Table 1.
Comment Letters Received

Table 2.
Comment/Response Matrix

Figure 1.
Definition of Root Zone, Capillary Fringe, and Threshold Terminology

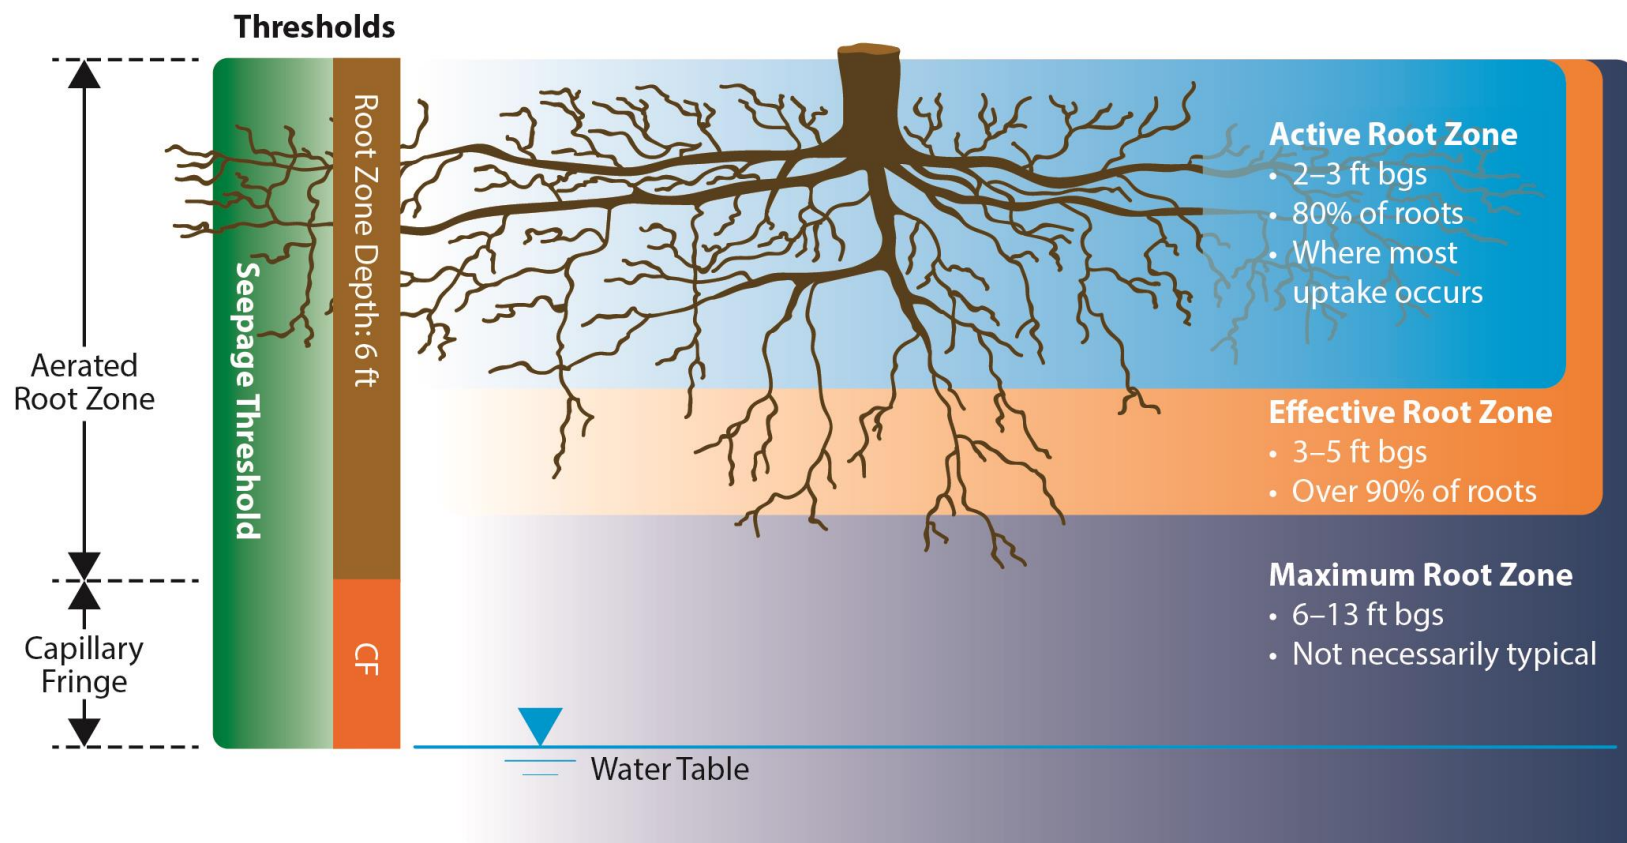
Comment ID	Comment	Response
		<p>We appreciate your efforts to review this study and we hope that Reclamation and landowners can work together to continue to improve the SMP based on the best available science to be protective of crops while not being overly conservative.</p>
DD-01	<p>I am deeply concerned in the consideration of decreasing the water table depth from 10' to 6' as proposed. Within these soils along the San Joaquin River (SJR) in Western Fresno, Madera, and Merced County, a water table at 6' will kill perennial crops. This depth would provide conditions that are unsuitable for perennial crop growth as follows:</p>	<p>Experts interviewed in development of the Phase 1 almond root zone study and literature reviewed agreed, with broad consensus, that the effective almond root zone was three to five feet in depth, with most roots (estimated at approximately 80 percent) in the top two feet. Reclamation has proposed an additional foot of aerated root zone, to include a factor of safety, and thus proposes a six foot almond root zone. The current proposal resulting from the scientific evidence gathered in the Study Plan defines the <u>almond root zone</u> as six feet. As at our December 17, 2015 meeting, this depth is not the depth to the top of the water table. This six feet of rooting depth would be added to the capillary fringe buffer to determine the groundwater level threshold (and minimum depth to the water table). The six foot almond root zone depth is supported by literature and recommendations of University of California, Cooperative Extension (UCCE) experts, which also advise a six foot root zone that includes a one foot additional factor of safety over the effective root zone. Reclamation's understanding is that after recent discussions you are now more comfortable with this approach and think a 6 foot almond root zone is appropriate, if we adjust the capillary fringe buffer to account for the full range of capillary fringe in the full variety of soil types.</p> <p>The peer review in 2012 suggested a 3.3 to 6.6 foot almond effective root zone.</p> <p>It is acknowledged that capillary fringe is an important consideration for protection of a defined aerated root zone. Appendix H of the SMP provides a definition of the water table threshold that can be calculated via the Agricultural Method (SMP, Appendix H, Section H.1.3.1 and H.2). This threshold comprises both a root zone depth (proposed at 6 feet as supported above) and a capillary fringe buffer. The capillary fringe buffer is added to that root zone depth per the specifications of Appendix H; however, observed field variation in capillary fringe has exceeded values provided in Appendix H in some areas and is a concern relative to protection of the root zone. Further evaluation of variation in capillary fringe within the project area is being considered as part of Phase 2 study efforts in order to potentially expand and refine capillary fringe values in the SMP.</p> <p>Reclamation recognizes various terminology may be unclear related to different components of the drained soil zone. It is important to clarify the difference between the root zone (and its component parts of maximum, effective, and active), capillary fringe, and water table. These components of an overall seepage threshold and their importance and interaction will be addressed by adding further explanation and illustration to distinguish between the</p>

<p>KB-01</p>	<p>As one of the largest almond growers in the state, Wonderful has serious concerns on adjusting seepage thresholds for almonds from the current root zone level of 9'. Many site specific conditions contribute to the impact that water levels can have on almond tree health and must be analyzed on a case-by-case basis. Lowering the threshold across the board, or even after a phase 2 "field investigation of almond root zone characteristics," cannot properly account for unique soil, salt and other site specific characteristics which could cause varying water levels to have detrimental impact on almond trees resulting in potentially significant economic losses. For example, some of the soil types on the New Columbia Ranch can hold water above the measured groundwater level, creating saturation conditions than can kill critical roots and push salts into the root zones.</p>	<p>Experts interviewed in development of the Phase 1 almond root zone study and literature reviewed agreed, with broad consensus, that the effective almond root zone was three to five feet in depth, with most roots (estimated at approximately 80 percent) in the top two feet. Reclamation has proposed an additional foot of aerated root zone, to include a factor of safety, and thus proposes a six foot almond root zone. The current proposal resulting from the scientific evidence gathered in the Study Plan defines the <u>almond root zone</u> as six feet. As at our December 17, 2015 meeting, this depth is not the depth to the top of the water table. This six feet of rooting depth would be added to the capillary fringe buffer to determine the groundwater level threshold (and minimum depth to the water table). The six foot almond root zone depth is supported by literature and recommendations of University of California, Cooperative Extension (UCCE) experts, which also advise a six foot root zone that includes a one foot additional factor of safety over the effective root zone. Reclamation's understanding is that after recent discussions you are now more comfortable with this approach and think a 6 foot almond root zone is appropriate, if we adjust the capillary fringe buffer to account for the full range of capillary fringe in the full variety of soil types.</p> <p>The peer review in 2012 suggested a 3.3 to 6.6 foot almond effective root zone.</p> <p>It is acknowledged that capillary fringe is an important consideration for protection of a defined aerated root zone. Appendix H of the SMP provides a definition of the water table threshold that can be calculated via the Agricultural Method (SMP, Appendix H, Section H.1.3.1 and H.2). This threshold comprises both a root zone depth (proposed at 6 feet as supported above) and a capillary fringe buffer. The capillary fringe buffer is added to that root zone depth per the specifications of Appendix H; however, observed field variation in capillary fringe has exceeded values provided in Appendix H in some areas and is a concern relative to protection of the root zone. Further evaluation of variation in capillary fringe within the project area is being considered as part of Phase 2 study efforts in order to potentially expand and refine capillary fringe values in the SMP.</p> <p>Reclamation recognizes various terminology may be unclear related to different</p>

Comment ID	Comment	Response
		terminologies. Please refer to Figure 1 for a graphical definition of these terms.
DD-02	The depth does not take into account capillary fringe, which can range from 2-3' in loam soils common to this area along the SJR. The width of capillary fringe has been confirmed through studies performed by Cal Poly, San Luis Obispo, and my own personal observations with backhoe pits dug in farmer's fields within the area;	It is correct that the study did not focus on capillary fringe. The Study Plan was intended to focus on root depth, which is the depth of aerated root zone that should be protected above the groundwater and associated capillary fringe. Reclamation understands that the observed field variation in capillary fringe has exceeded thresholds provided in Appendix H in some areas. Further evaluation of variation in capillary fringe within the project area is being considered as part of Phase 2 study efforts in order to potentially expand and refine capillary fringe values in the SMP.

Comment ID	Comment	Response
		<p>components of the drained soil zone. It is important to clarify the difference between the root zone (and its component parts of maximum, effective, and active), capillary fringe, and water table. These components of an overall seepage threshold and their importance and interaction will be addressed by adding further explanation and illustration to distinguish between the terminologies. Please refer to Figure 1 for a graphical definition of these terms.</p> <p>Reclamation will operate 2016 Restoration Flows based on the existing almond root zone of 9 feet.</p> <p>Also, as discussed at our December 17, 2015 meeting, the UCCE experts appear to be in agreement about the 6 foot almond root zone. Our ongoing area of controversy is in regards to the appropriate capillary fringe buffer. Based on your and other's comments, Reclamation proposes to change the Seepage Management Plan in two ways: 1) to change the almond root zone to 6 feet and 2) to change the capillary fringe buffer to whatever is the greatest capillary fringe anticipated in the fields around a given well, based on the drill log of that well and any other information available. This would change the capillary fringe buffer to up to 4 feet depending on soil type. Thus, the threshold may stay the same for some properties but the components would change (from 9 foot root zone plus 0.5 or 1 foot capillary fringe, to 6 foot root zone plus 0.5 to 4 foot capillary fringe).</p>
